ORIGINATION FORM

Proposed Revisions to a Standard Plans Index

Index Number: 455-154
Sheet Number (s): 1
Index Title: 54" Precast/Post-Tensioned CFRP & SS
Concrete Cylinder Pile

INDEX	SHEET
455-154	1 of 3

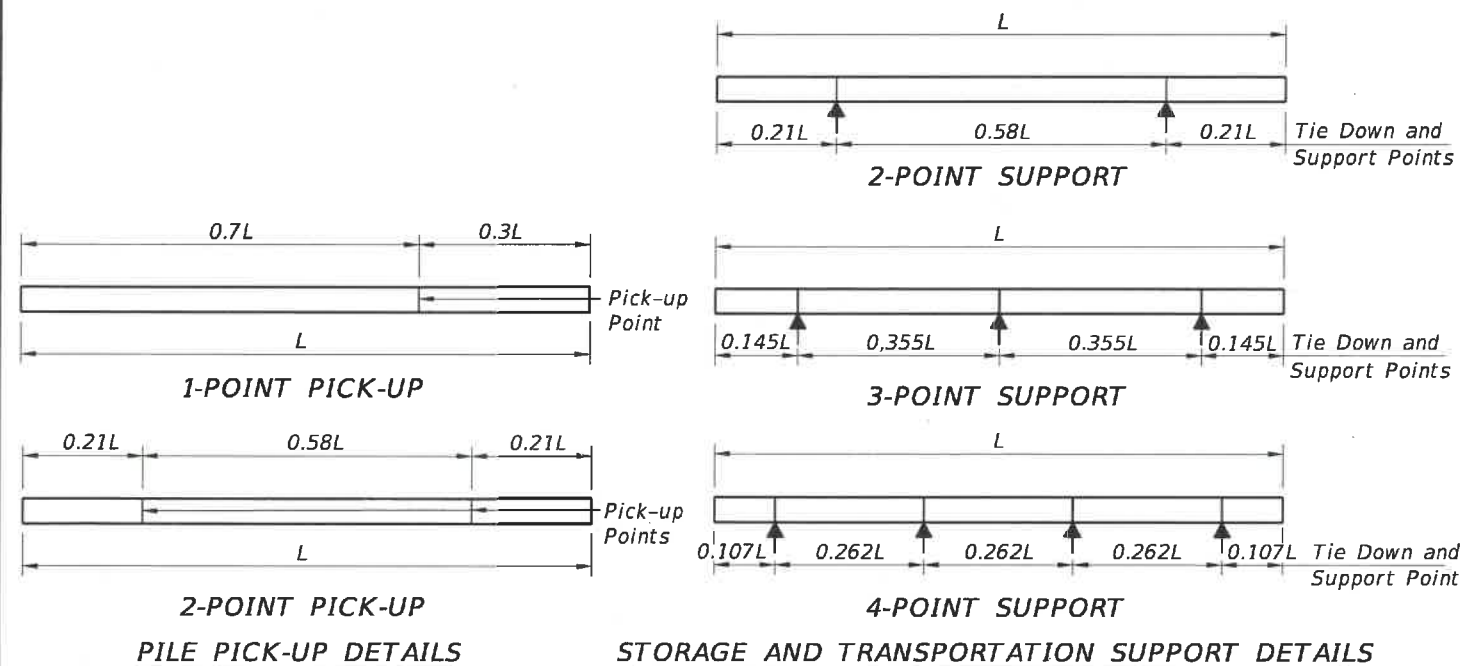
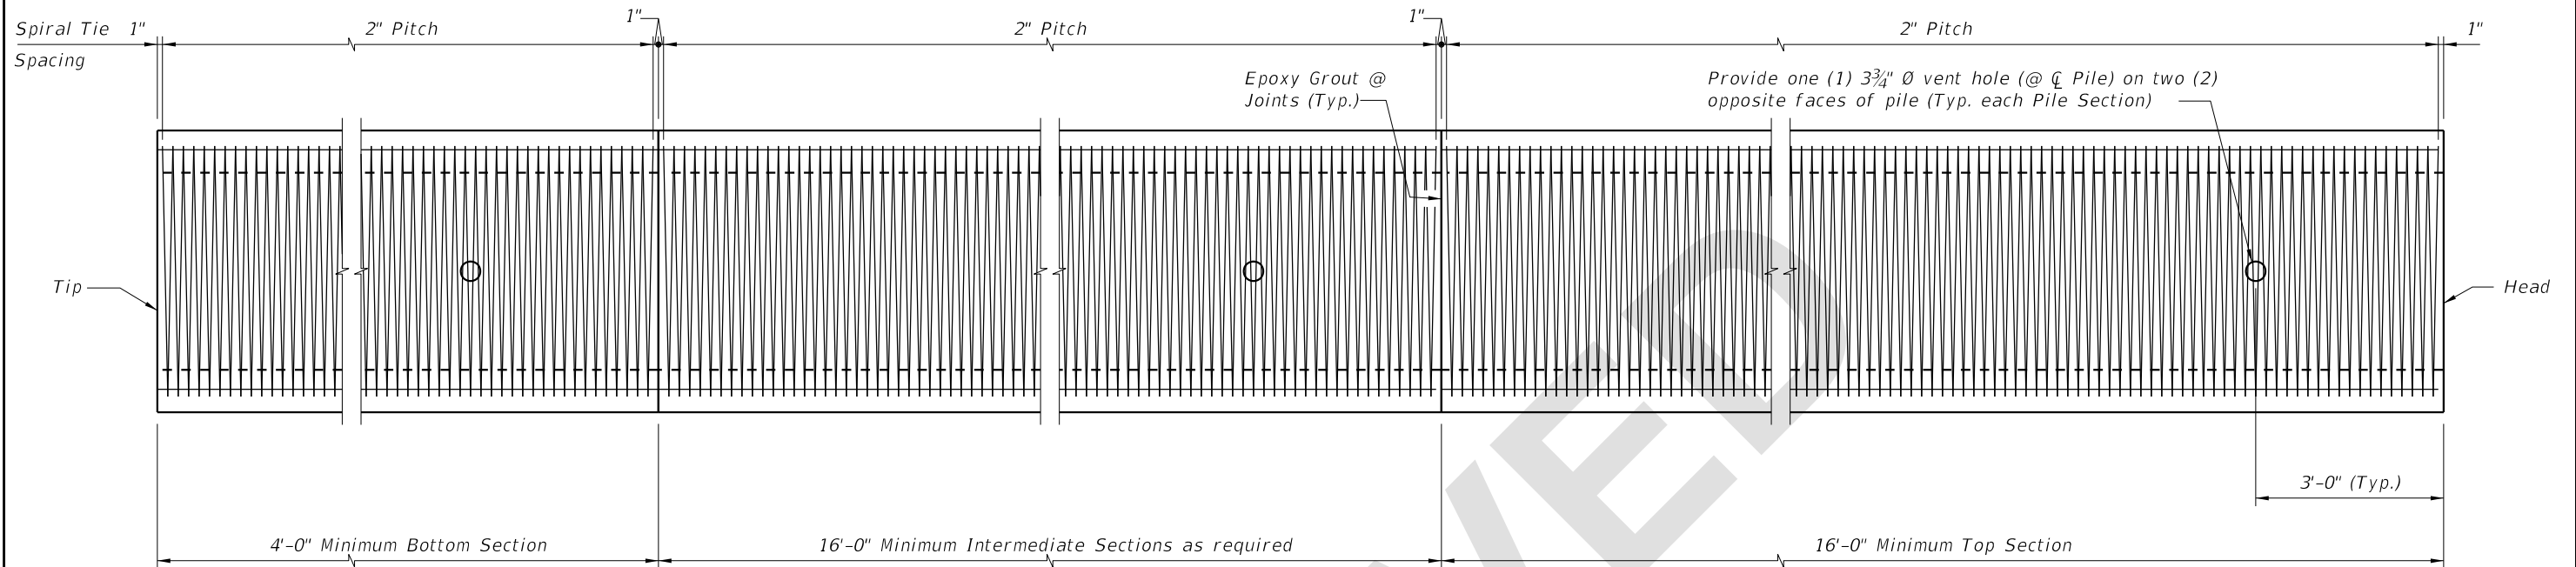
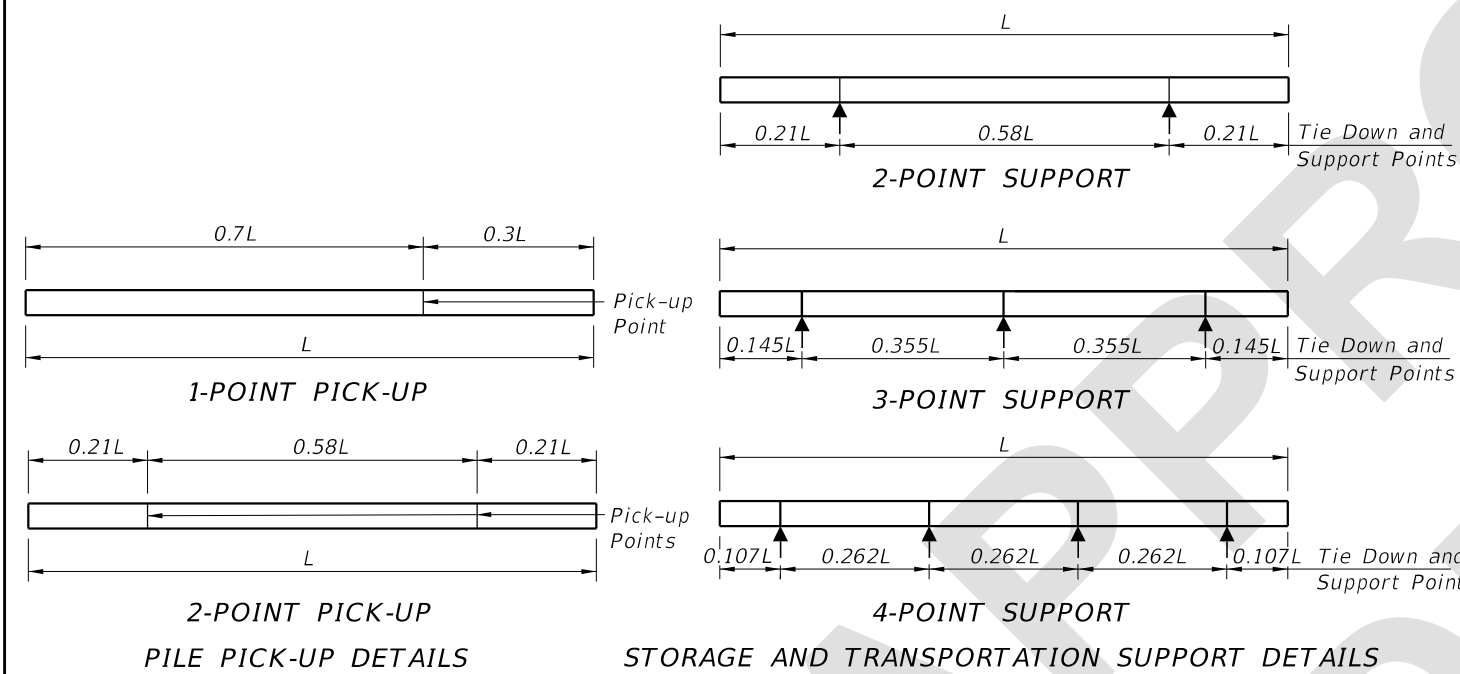
Changed Class V (Special) concrete to Class V.

- Work this Index with the Pile Data Table in the Structures Plans.
- Concrete:
 - Piles: ~~Class V (Special)~~
 - Splice: ~~Class IV~~
 - See "GENERAL NOTES" in Structures Plans for locations where the use of Highly Reactive Pozzolans is required for options using stainless steel strand and reinforcing.

1. Work this Index with the Pile Data Table in the Structures Plans.
2. Concrete:
 - A. Piles: Class V
 - B. Splice: Class IV
 - C. See "GENERAL NOTES" in Structures Plans for locations where the use of Highly Reactive Pozzolans is required for options using stainless steel strand and reinforcing.
